Duke Cogema Stone & Webster

Mixed Oxide Fuel Fabrication Facility

Responses to the Request for Additional Information

on the Environmental Report, Revisions 1 & 2

Attachment 8 a. WSB topography at 10 ft intervals

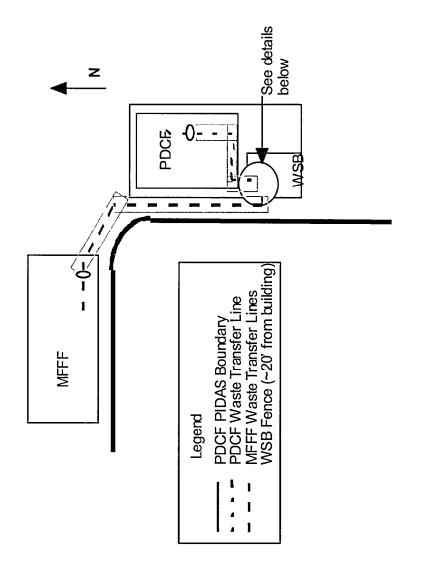
8. Provide a site contour map for the PDCF/WSB area (similar to the one that was previously provided for the MOX facility area).
